NHTSA Recall Number: 21V-813

Trail King Recall Number: TK202105

IMPORTANT SAFETY RECALL SECOND NOTIFICATION

AACS/ACS SLIDER PAN CRACKING

Crack near the inside bolt.

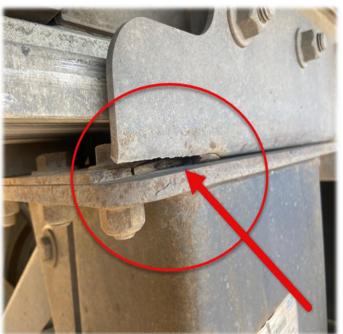
On certain step deck trailers with a rear sliding axle, small cracks may appear in the front corners of the slide pan where the suspension bolts to the slide pan. If the cracks in the slide pan continue to develop and are not addressed, the cracks could propagate causing the suspension hanger to pull away from the slide pan structure.

The following pictures are examples of cracks in the front of the slider pan.

Trail King will repair the slider pan by adding reinforcements between the hanger and the slide pan. The repair will be provided on all affected trailers free of charge. Please contact your nearest Trail King Industries dealer to have your trailer inspected and repaired. You also can contact Trail King Industries directly at 1-800-843-3324 and our Customer Service Department will help you locate a dealer near you. We will send the parts needed to the dealer to repair your trailer.

Complete a thorough inspection of the slider pan documenting cracks or breaks you find. Contact a Trail King customer service representative with your findings. Follow the recall instructions for support.

While small cracks may be ground out and re-welded prior to installing the slider reinforcement kit; larger cracks should be reviewed with a TK customer service representative to ensure that no other action is required.
